TECHNICAL SERVICE BULLETIN

3.5L PowerBoost - Lariat/XLT/XL Trim Levels - Right Side Turbocharger Concerns

24-2264

Ford 2024 F-150	Engine: 3.5L PowerBoost Lariat/XLT/XL trim level
---------------------------	---

Figure 1

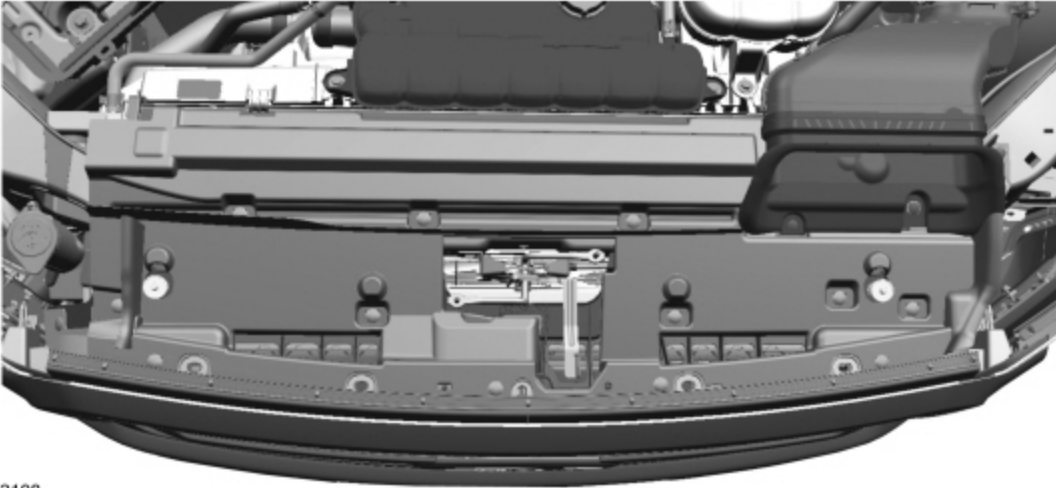
1. Does the upper air deflector match the one outlined in Figure 1?

(1). Yes - proceed to Step 2.

(2). No - this article does not apply. Refer to the WSM for additional diagnostics.

Figure 2

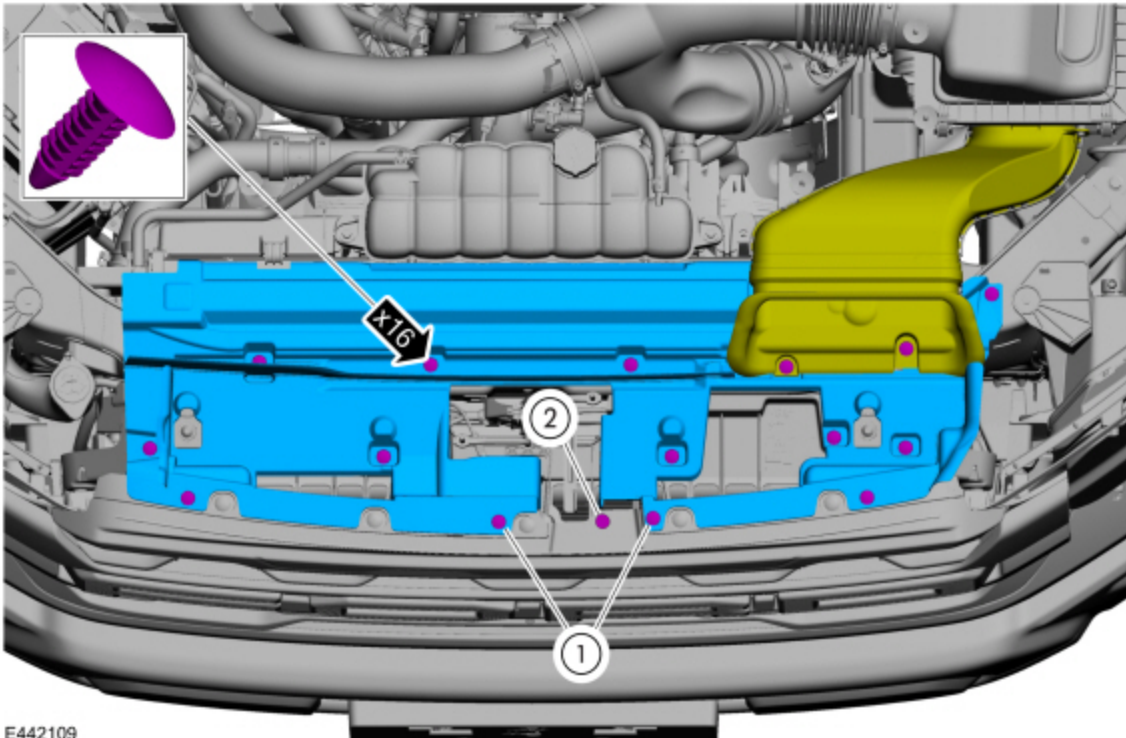
2. Remove and discard the upper radiator air deflector and the 15 air deflector push pin retainers. (Figure 2)

(1). Set the new air deflector in place and install 13 pin retainers except for the 2 shown in Figure 2, Callout 1 and the 1 shown in Figure 2, Callout 2

(2). Using the 2 remaining holes in the newly installed air deflector as a guide, use a 1/4 in. (6.5 mm) drill bit and drill a hole through the radiator grille at each location shown in Figure 2, Callout 1.

NOTE: Use a drill stop or tape set to a 1/4 inch depth on the drill bit as a guide to avoid drilling into components such as wiring on the back side of the grille.

(3). Install the remaining 2 pin retainers to secure the air deflector in place.

(4). Install a single pin retainer in the now exposed hole in the grille as shown in Figure 2, Callout 2.
